PCN# : P616AAB
Issue Date : Feb. 02, 2016

Information Only Notification

Change From: MKT-N08MRev1

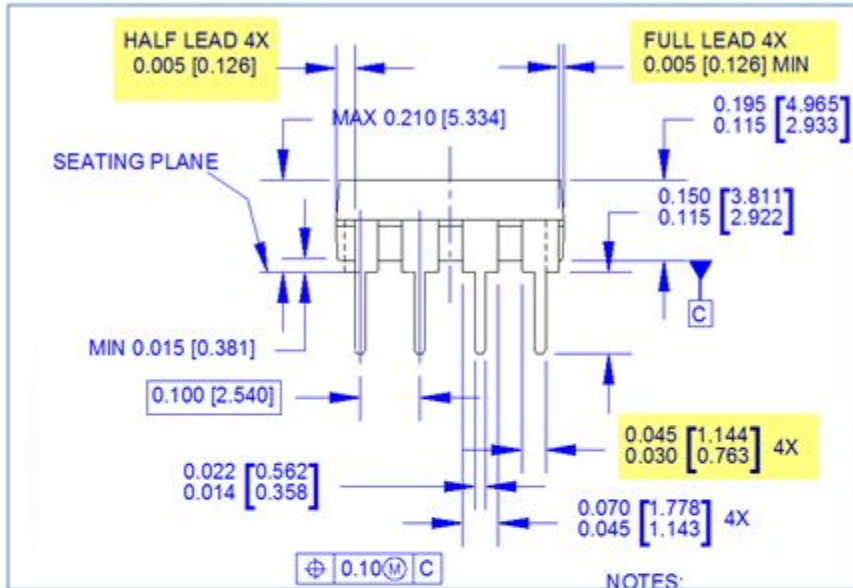
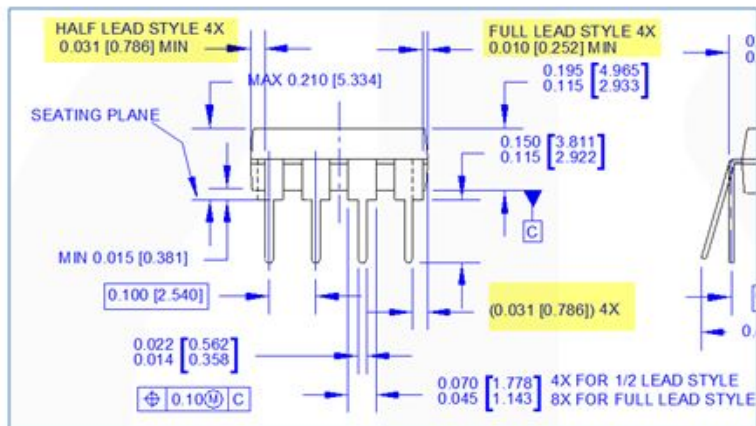
- 1) Package Drawing , MKT-N08M was Rev 1 (Page 17)
- see attached file for specifics of change

- 1) Package Drawing , MKT-N08M is now Rev 2 (Page 17)

- A) THIS PACKAGE CONFORMS TO JEDEC MS-001 VARIATION BA WHICH DEFINES 2 VERSIONS OF THE PACKAGE TERMINAL STYLE WHICH ARE SHOWN HERE.
- B) CONTROLLING DIMS ARE IN INCHES
- C) DIMENSIONS ARE EXCLUSIVE OF BURRS, MOLD FLASH, AND TIE BAR EXTRUSIONS.
- D) DIMENSIONS AND TOLERANCES PER ASME Y14.5M-2009
- E) DRAWING FILENAME AND REVSN: MKT-N08MREV2.

Fairchild is correcting the physical dimension errors found with package drawing, and correcting to proper dimensions on the area from the package-end to the outer-leads.
